TO: Members of the MAG Specifications and Details Committee

SUBJECT: MEETING NOTIFICATION AND TRANSMITTAL OF AGENDA

MEETING MINUTES FROM THE
MARICOPA ASSOCIATION OF GOVERNMENTS
STANDARD SPECIFICATIONS AND DETAILS COMMITTEE

February 6, 2008

TYPE 2 SAFETY POST
N.T.S.

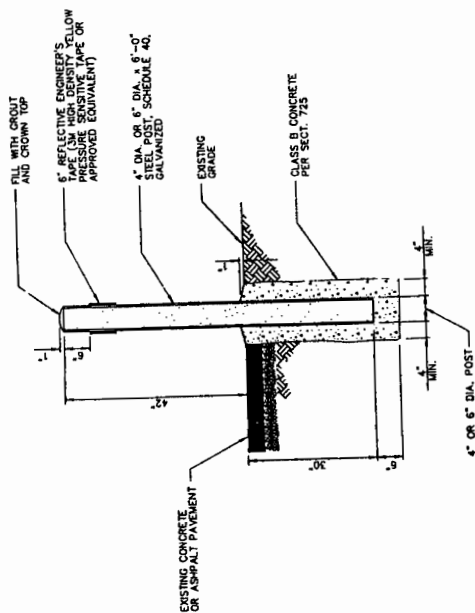
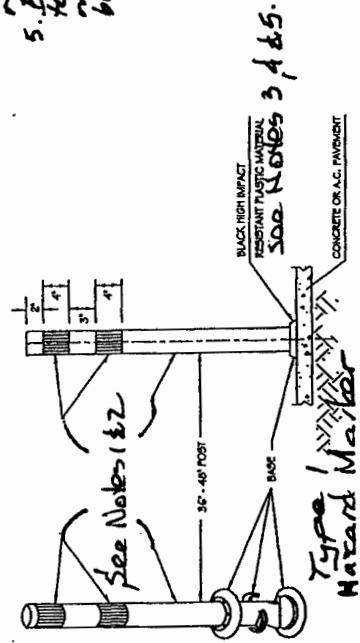
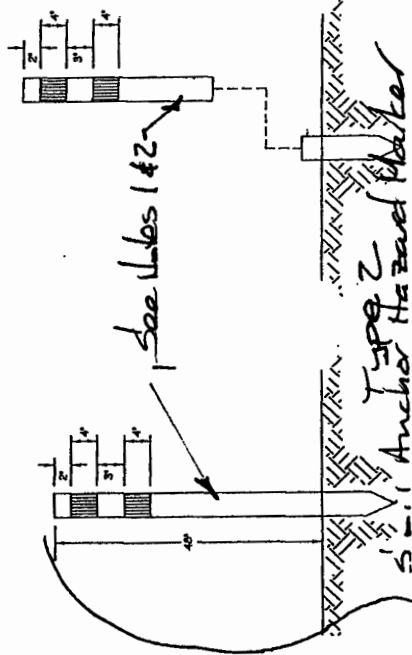
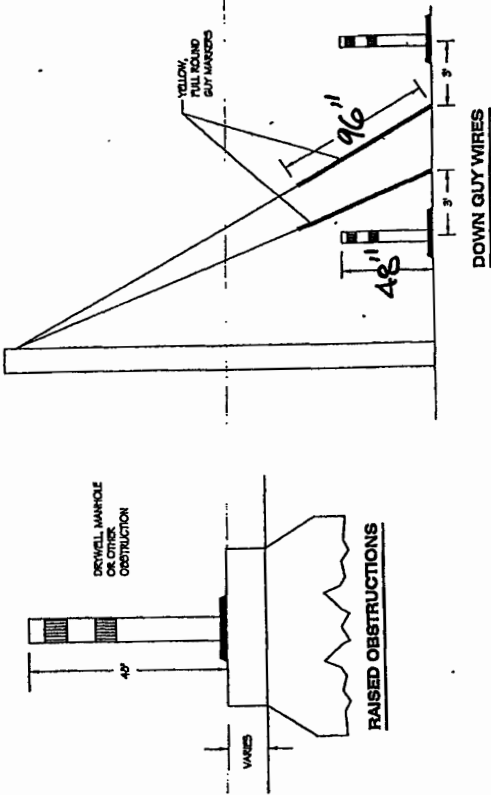
One such standard detail that is currently included in the MAG Standard Specifications and Details is MAG Detail 140 for safety post installations. This Detail is either modified or added to by the current municipal details in the City of Chandler and City of Mesa. The information in both these details can be deleted from the agency modifications/additions and added as a one (1) page detail in the 100 Series of the MAG Standard Details section.

- There are no differences between safety post Types 1 & 2 except for height (MAG 42", Mesa 72"). Combine into a single detail and request that City of Mesa delete their safety post detail from M-62.4. Including wording from Mesa detail Note 8 that references their height for the specific use noted on the detail.

- Notes:
1. Yellow tubular markers shall have a yellow post and yellow high intensity grade 1 shock. Orange tubular markers shall have an orange post and white high intensity reflective sheeting.
 2. Post shall be flexible, high impact resistant, plastic material.
 3. Contractor shall clean roadway surface prior to placement of flexible tubular marker.
 4. Flexible tubular markers shall be installed with an adhesive as per tubular marker manufacturer's recommendations.
 5. Base shall be cemented to surface with epoxy material as recommended by the manufacturer.

- NOTES:
1. HAZARD MARKERS SHALL BE INSTALLED WHEN AN OBSTRUCTION MAY POSE A HAZARD TO MOTORIZED VEHICLES, MOWING EQUIPMENT, PEDESTRIANS, MAINTENANCE OPERATIONS OR AS DIRECTED BY THE ENGINEER.
 2. HAZARD MARKERS SHALL MEET THOSE SPECIFICATIONS SHOWN **AT RIGHT**.
 3. **HAZARD MARKERS** MAY BE USED AROUND RAISED OBSTRUCTIONS AS AN ALTERNATE; HOWEVER, THREE (3) MARKERS MUST BE PLACED AT 120° INTERVALS AROUND THE OBSTRUCTION.

PAVEMENT REPLACEMENT FOR TRENCHES (T-TOP)

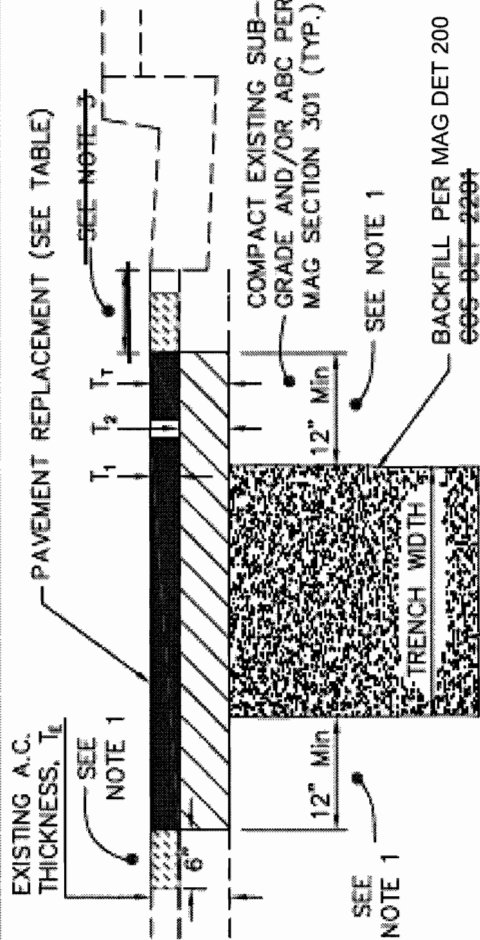
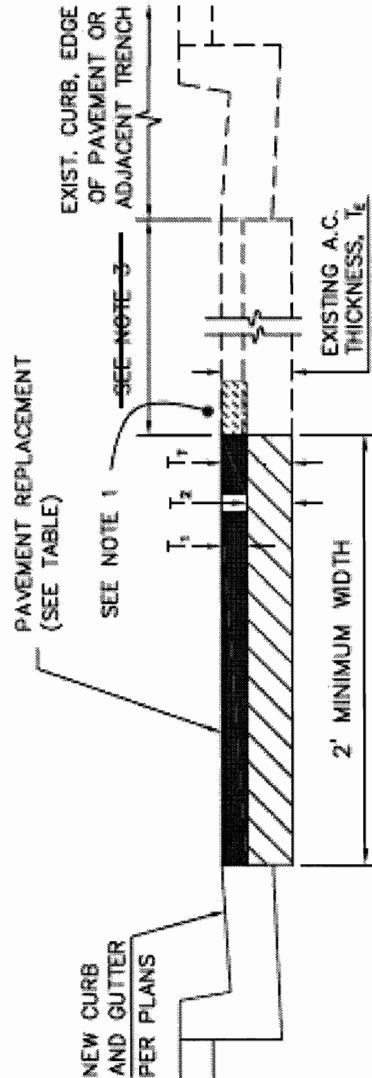
Below are the modifications to special provisions needed by Scottsdale when using proposed MAG Detail 200, revised MAG Section 336 and existing MAG Section 601. These modifications can be done in the City of Scottsdale Supplement to MAG Section 336 in lieu of COS Detail 2201. COS Detail 2000 includes extensive pavement section replacement requirements and should be modified (as attached) to delete duplication of trenching requirements in proposed MAG Detail 200.

It is recommended that Scottsdale Supplement Section 336.2.4 be deleted as this paragraph has been included in revisions to MAG Section 336.
